IEC 62908-12-10
Edition 1.0 2017-06

TOUCH AND INTERACTIVE DISPLAYS –

Part 12-10: Measurement methods of touch displays –
Touch and electrical performance

CORRIGENDUM 1

Figure 12 – Linearity definition

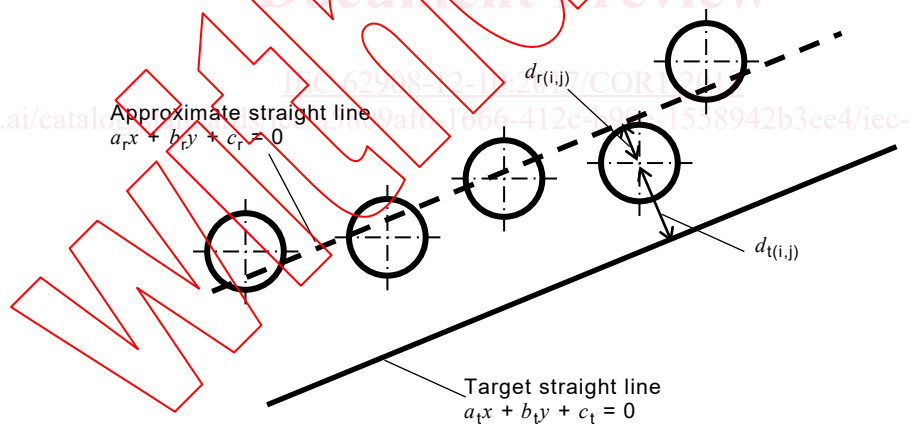
Replace the first sentence of the second paragraph with:

Replace Figure 12 with:

The distance between the centre of the reported point and straight line is calculated by the formula in Figure 12.
